DEVELOPMENT REVIEW BOARD
SUPPLEMENTAL SUBMITTAL

PROJECT NO. PR-2019-002277
Application No. SI-2019-00246

SUBMITTAL DESCRIPTION: DRB Site Plan Resubmittal.

**RE: Adagio Apartments
PR-2019-002277**

A-302

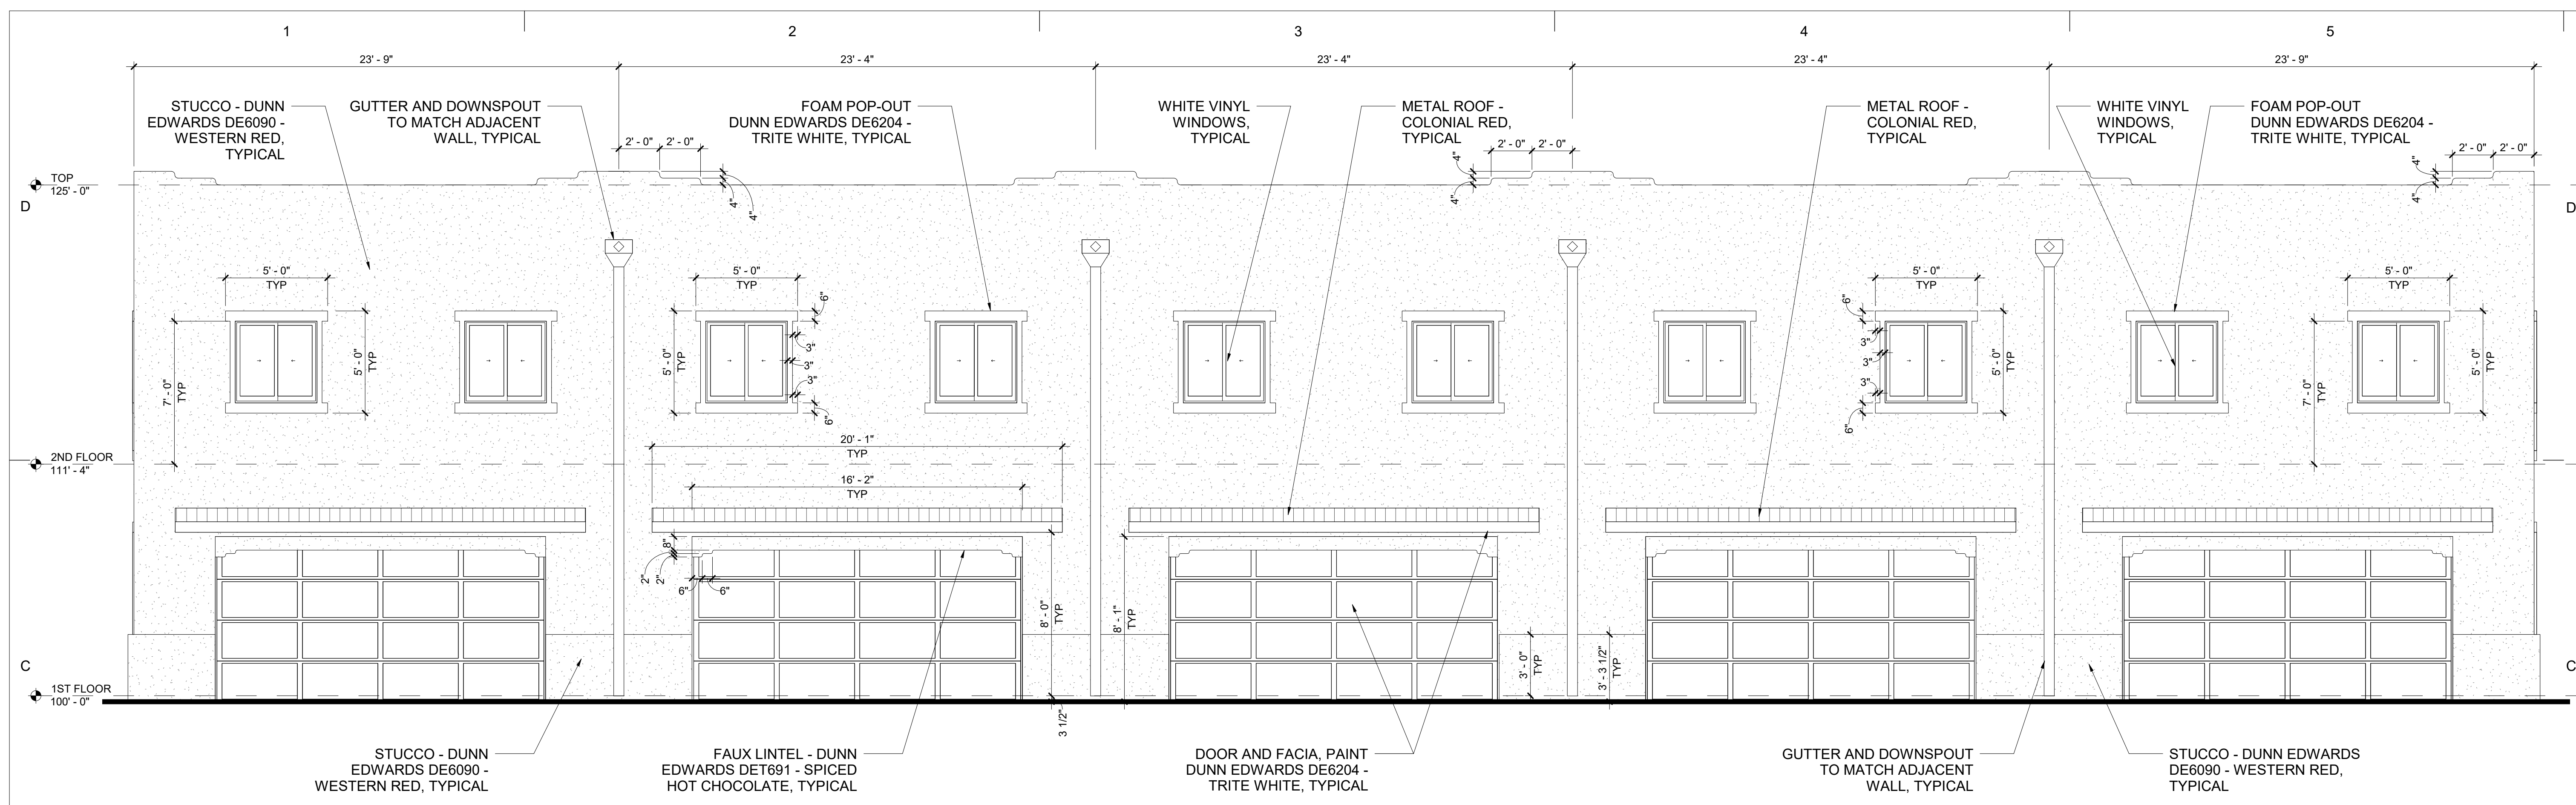
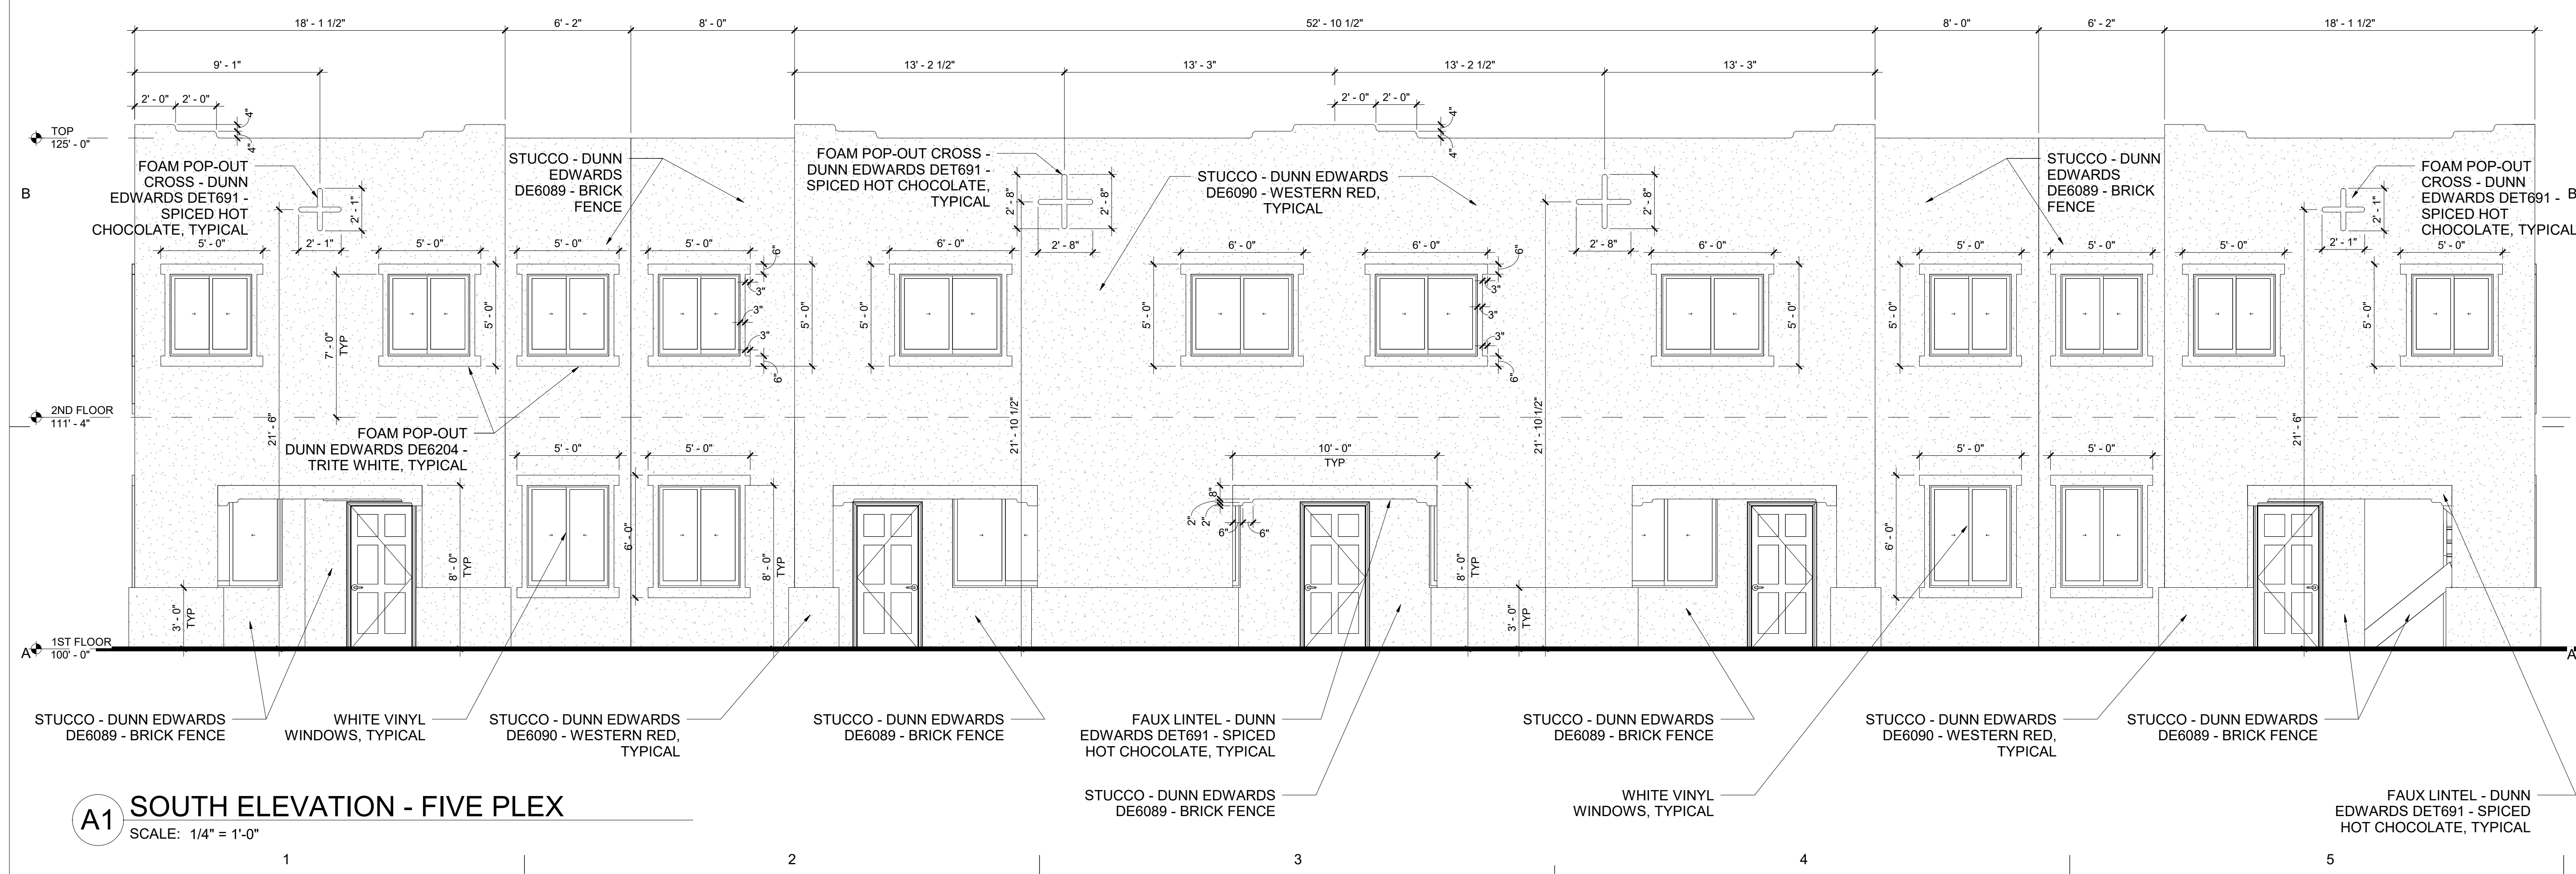
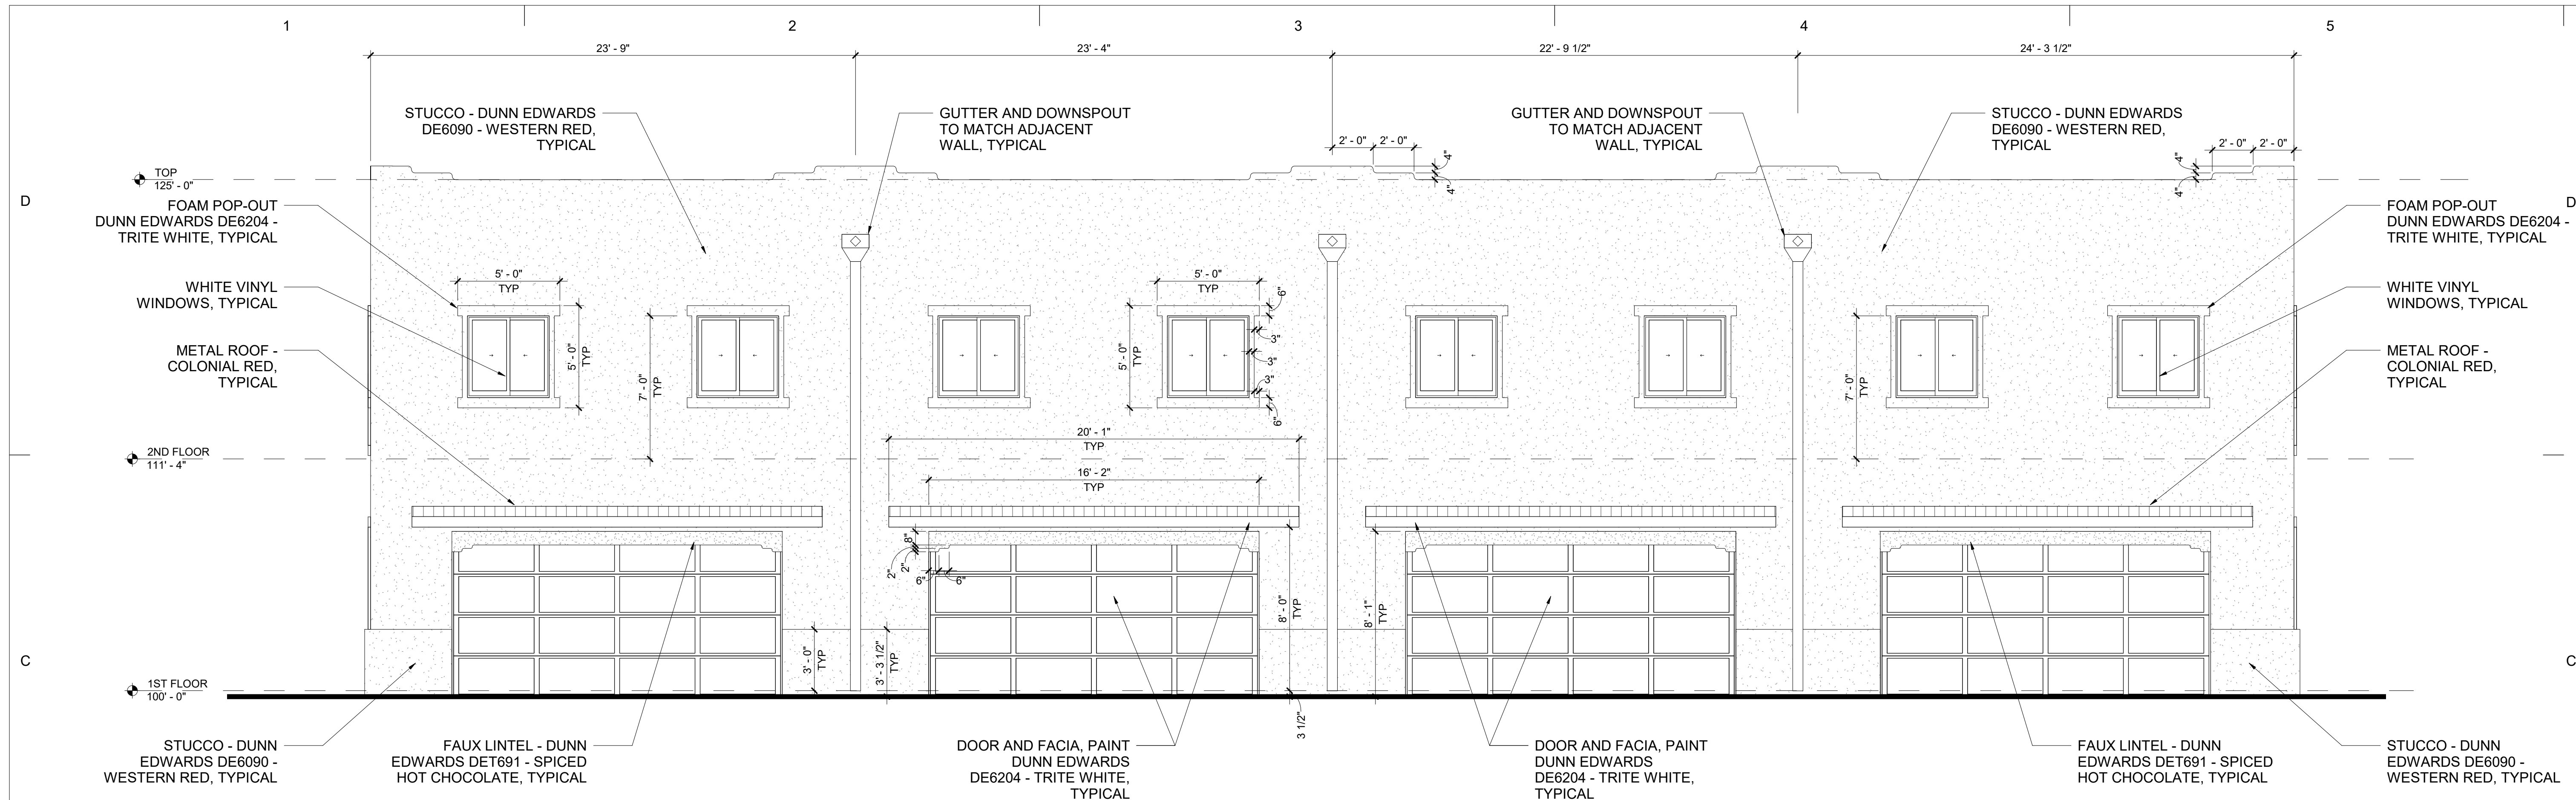
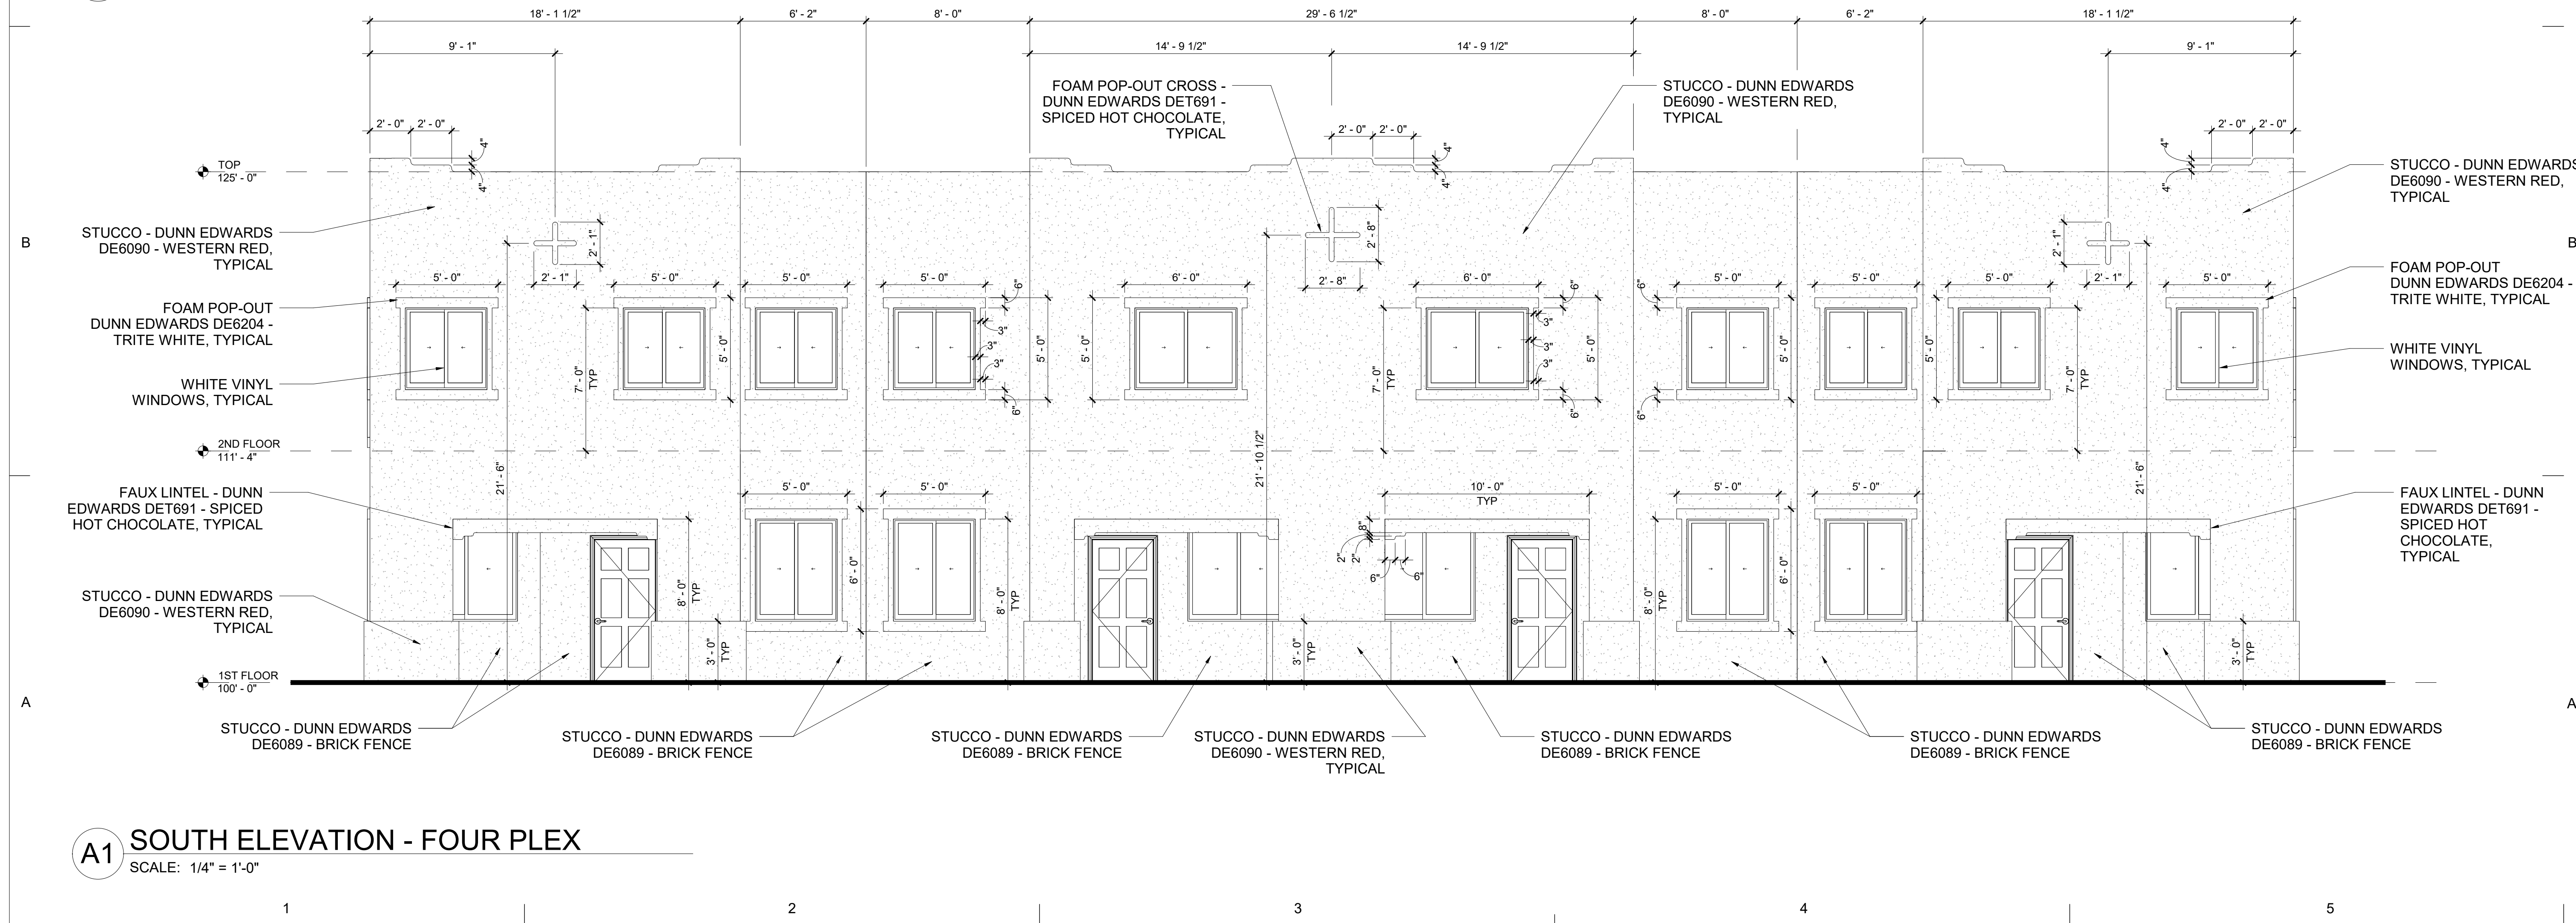
- / The townhomes shall have a color palette consistent with the depiction on the color elevations included in the October 20 supplemental submittal from the applicant.

- o *Response: Revised architectural elevations attached provides color labels consistent with the rendering provided.*
- / All Site Plan sheets must be sealed and signed by a design professional licensed in the State of New Mexico. The Landscape Plan must be sealed and signed by a Landscape Architect licensed in the State of New Mexico.
